SERVICE BULLETIN

from: TRIO-KENWOOD COMMUNICATIONS, INC.

SUBJECT: TS-120S ANT INPUT TRNASTORMER REPLACEMENT

DATE 7/12/79

▼ RF UNIT (X44-1260-01)

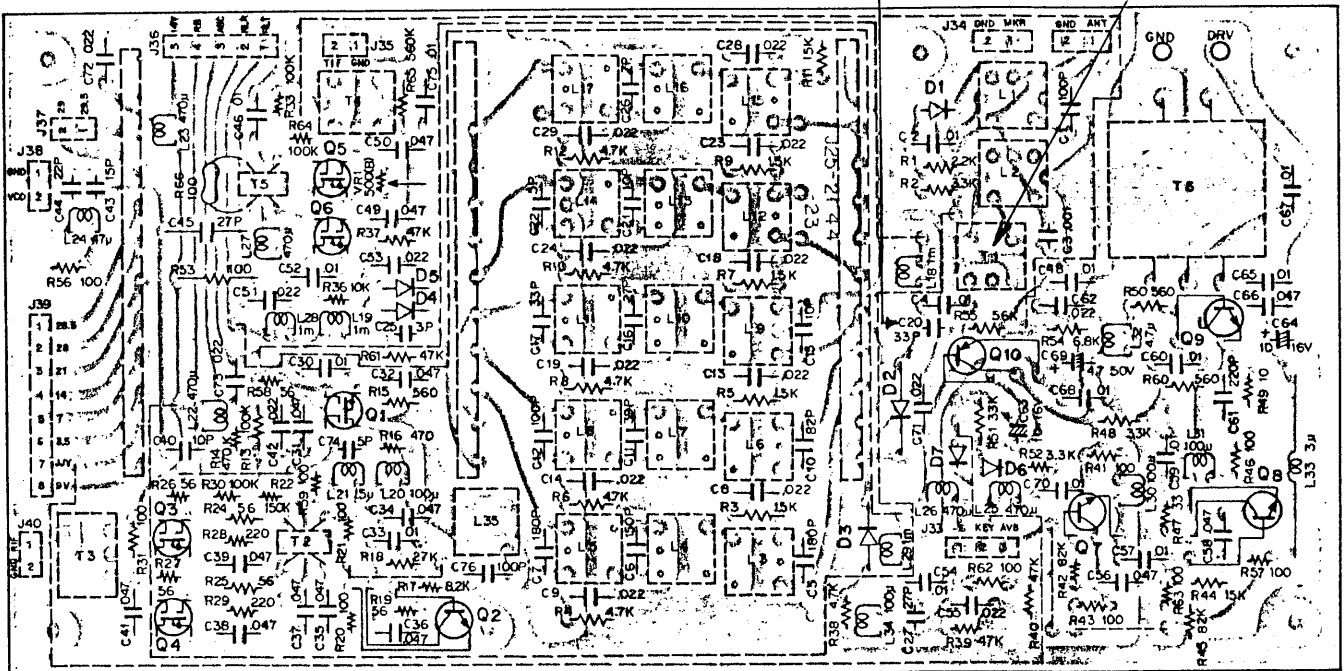
TS-120S transceivers subject to strong static fields or similar hi current atmospheric discharges may suddenly exhibit low RX sensitivity on all bands. TX will be OK. You may suspect T1 on the RF unit, X44-1260-01.

When replacing or ordering T1, L43-0696-35, also check the value of C20. If it is 33pF, just replace and repaek the transformer.

First production transceivers will have a 15pF cap for C20. When changing T1, also replace C20 with a 33pF capacitor, and repeak the circuit.

Old part number;	L34-0696-05	ANT coil
New Part number;	L34-0696-35	ANT coil
Old capacitor was 15pf,	replace with	
New Part number	CC45RH1H330J	33pf
